ADDENDUM NO. 1
City of Lincoln
"O" Street, 2nd Street to 9th Street (Harris Overpass)
Bridge C.I.P. #701781
State Project BR-5266(1) CN 12572
SPEC. NO. 07-186
June 19, 2007

1. STORM SEWER PIPE QUANTITY MODIFICATIONS

EARTHWORK MEASUREMENT DIAGRAM
FOR ADDENDUM NUMBER 1

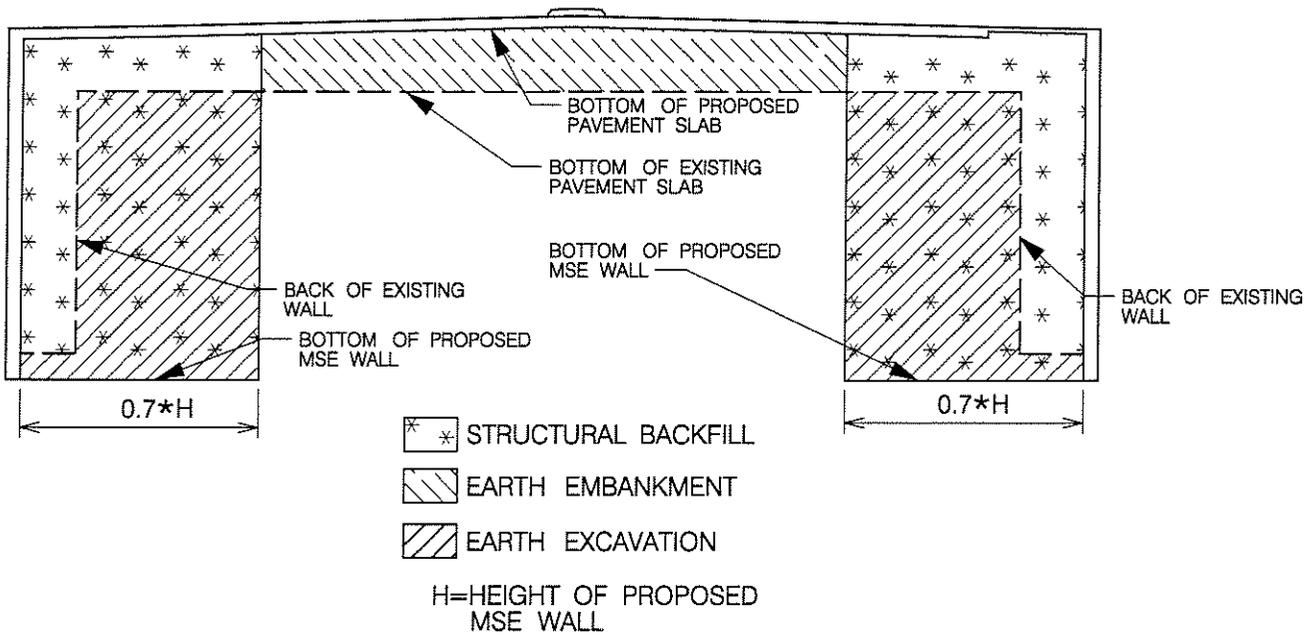
Is the cap for the paving included in the earthwork quantity?

Attached to this addendum is a sketch showing the methodology used to measure the earthwork and the structural backfill for the bid item quantities shown on the bid form. This sketch is for measurement information only and shall not be the basis for design. The Contractor is responsible for providing the MSE wall design.

DIAGRAM INTENDED TO REFLECT THE METHODOLOGY FOR MEASUREMENT OF EXCAVATION, EMBANKMENT, AND STRUCTURAL BACKFILL SHOWN IN THE SUMMARY OF QUANTITIES. CONTRACTOR SHALL BE RESPONSIBLE FOR DESIGN OF MSE WALL.
